Document No: 1774-LET-465 – ISS 2  
14 July 2017

**Response to Letter from Office of Environment and Heritage (DOC 16/630090 SSD 6236 Amended EIS Exhibition) (28 February 2017)**

**Figure 1. Ropes Creek Tributary illustrating existing and amended proposal features**

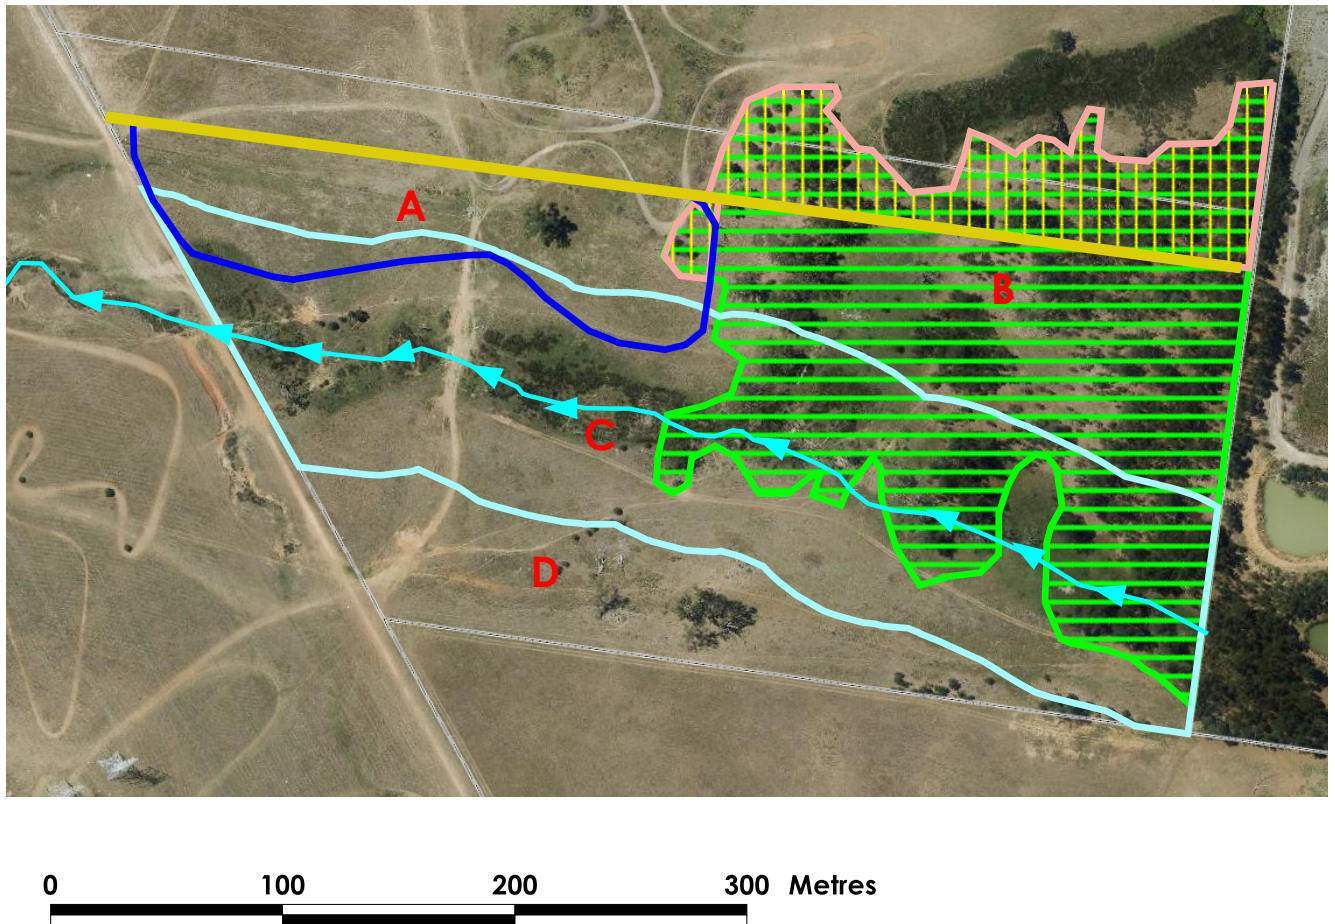
*OEH recommends that additional land containing endangered ecological communities be retained with the development footprint and/or offsite offsets provided. App HH5 provides project design justifications for not providing further on site offsetting, and in relation to offsite offsets, it states that "water supplied, flood prone wetland suitable for an offset in the Sydney metropolitan area cannot be easily procured" (page 41). OEH considers that if options for onsite offsetting are limited or not feasible, then an effort to secure offsite offsets should be made and documented. DPE should be satisfied that all reasonable attempts have been made to procure offsite offsets.*

The previous area of River Flat Eucalypt Forest (RFEF) Endangered Ecological Community (EEC) proposed to be removed was approximately 2.89 ha. The footprint of the EFW proposal has been modified so that only 1.03 ha is proposed to be cleared (Appendix 1). This change has avoided the clearing of approximately 1.86 ha. This change meets the first objective of the “avoid, mitigate, offset” principle.

A 50 m riparian area consisting of a 40 m riparian zone and a 10 m buffer is displayed in Appendix 1. This area is proposed to be revegetated consistent with the guidelines of the NSW Office of Water document *Guidelines for vegetation management plans on waterfront land* (July 2012).

The proposed development footprint has been modified so that an additional area of the Endangered Ecological Community River Flat Eucalypt Forest has been retained. Offsite requirements will be achieved by a mix of the following methods:

The areas on-site that are available for offsetting include some of the components of the land south of the development footprint line (Edge of laydown pads, Figure 1). This area is made of four portions:

1. The Bio-retention basin and sides. A constructed feature – not suitable as an offset (red "A")
2. The portion of RFEF outside the Riparian area – 40 m + 10 m. (red "B")
3. The Riparian area – 40m + 10m (excluding the Bio-retention basin and sides); (red "C")
4. The portion south of the Riparian area; (red "D")

It is proposed that portions B, C and D are Biobanked to provide protection and management in perpetuity. If area C is unavailable for Biobanking as some biodiversity conservation measures are already proposed (revegetation work consistent with NSW Office of Water guidelines) then this area will be protected through a positive covenant. OEH will provide advice on whether the Riparian area can be "Biobanked" and what discounting of credits will be applied to the Biobanking Methodology for the calculation of credits within area C.
